Access Report

**Health Services Facility &
Retail Premises**

31-33 Smith Street
CHARLESTOWN NSW 2290

For: GPV Property Pty Ltd
Ref: LP_22080

Figure 2 | Level 1 Plan

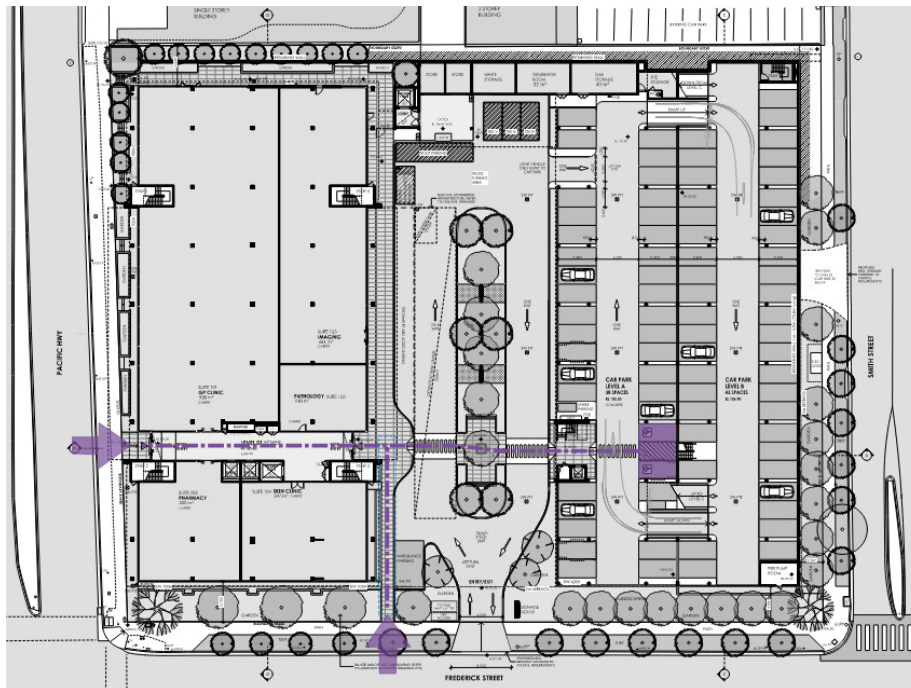
An accessible path of travel is provided from both Frederick Street and Pacific Highway to the building entrances.

An accessible path of travel is provided from accessible carparking spaces at Level 1 (ground level) to the building entrances and from the accessible car parking at Levels 2 & 3 to the lift lobbies.

Designated accessway are generally 1800mm wide and offer a level surface.

Carparking is provided over three (3) levels on the eastern side of the building. Plans note a total of two hundred and forty-eight (245) carparking spaces, six (6) of which are provided as accessible carparking spaces.

The overall configuration of the accessible car parking spaces achieves compliance with current legislation including dimensions of the spaces shared space, chevron markings and provision of a bollard.

Kerb ramps are provided at each level of the multi-deck carpark for access to the lift lobbies.

Overall configuration is in keeping with current legislation.
Ensure a maximum gradient of 1:8 is achieved.

Stairs are provided as a part of the pedestrian access from the Pacific Highway to the building (1 off) and from Frederick Street to Level 1 carparking area (2 off).

Overall configuration of the stairs offers compliance with current accessibility legislation including the handrail to both sides. Detailed design to include tactile indicators and contrasting non-slip nosing strips.

Ensure the stairs to Pacific Highway are set back from the property boundary.

The accessway from the allotment boundary along the Pacific Highway to the entry doors includes a section with gradient of 1:20. This is technically a walkway and will achieve compliance with current accessibility requirements.

Double automatic sliding doors are provided to the main entrances (2 off) at Level 1 and to the Medical Imaging Suite. The use of this type of door is encouraged as it maximizes access for persons with a disability.
